<b>Company</b>	Trenz Electronic GmbH
<b>PCN Number</b>	PCN-20210613
<b>Title</b>	TE0783-02 eMMC Change and Product Update
<b>Subject</b>	BOM change
<b>Issue Date</b>	2021-09-09

## 2.4 #4 Set S/N to not fitted

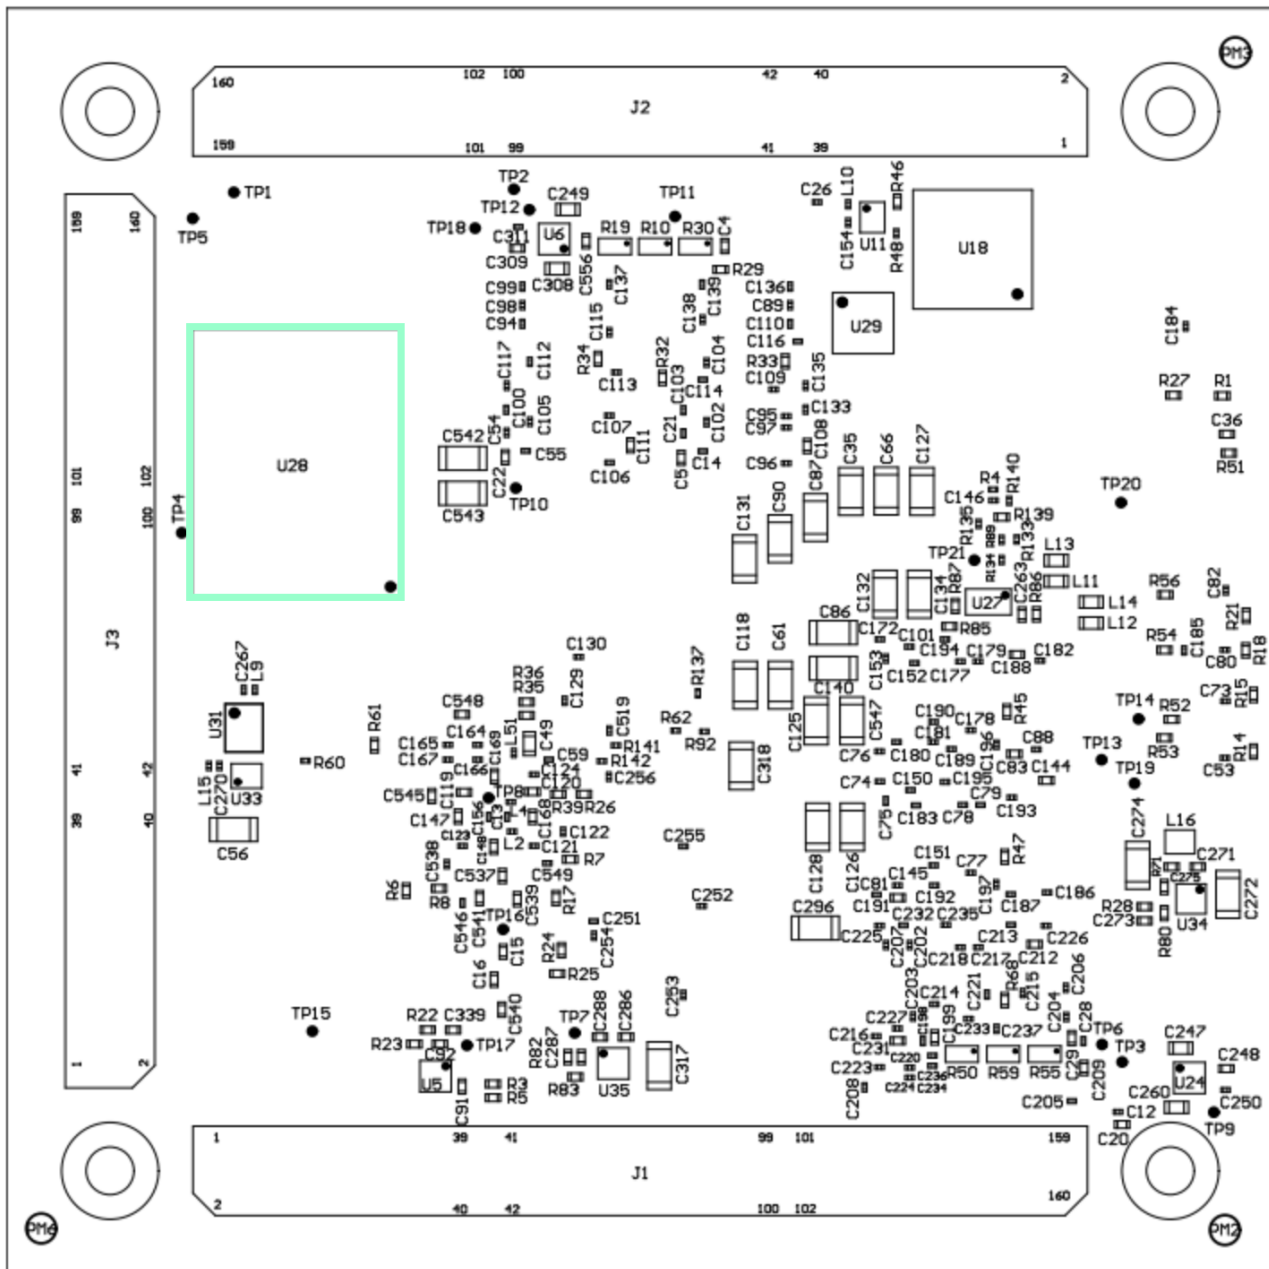
**Type:** BOM change

**Reason:** Part is end of life.

**Impact:** Track it pad no more available.
